Product Change Notification (PCN)

PCN TRACKING NO:PCN-15012017

Subject: Product Change Notification (PCN) for Alliance SRAM's (Low Power 32M)

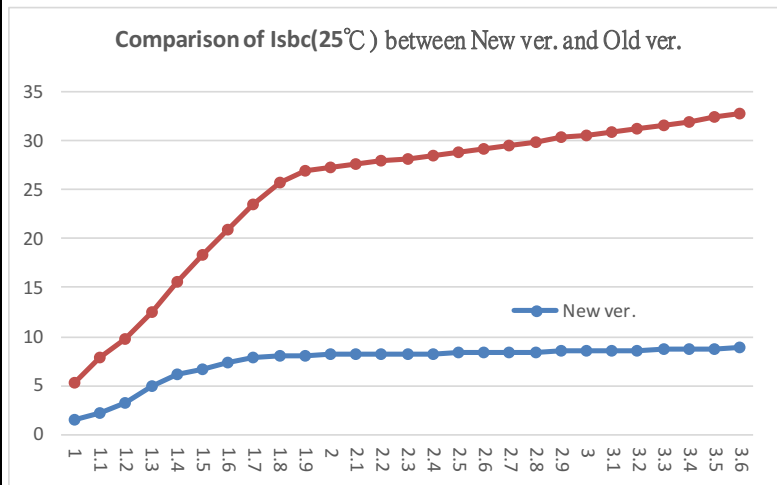
Benefit of Change: The change will enable Alliance memory to continue the shift to the 90nm technology for this family. AS6C3216A-55TIN keeps the same AC specifications as that on AS6C3216-55TIN. Besides that, the operating current on AS6C3216A-55TIN has got great improvement, shown as below:

Vcc	I _{cc} (55ns, 25°C)	
	New ver.	Old Ver
1	1.51	5.19
1.1	2.09	7.81
1.2	3.26	9.69
1.3	4.91	12.44
1.4	6.13	15.56
1.5	6.67	18.32
1.6	7.38	20.92
1.7	7.93	23.5
1.8	8.06	25.76
1.9	8.09	27.06
2	8.12	27.31
2.1	8.14	27.68
2.2	8.18	28.03
2.3	8.2	28.24
2.4	8.26	28.51
2.5	8.3	28.85
2.6	8.34	29.29
2.7	8.38	29.58
2.8	8.42	29.92
2.9	8.46	30.35
3	8.52	30.61
3.1	8.56	30.96
3.2	8.62	31.27
3.3	8.67	31.58
3.4	8.71	32
3.5	8.77	32.42
3.6	8.81	32.77
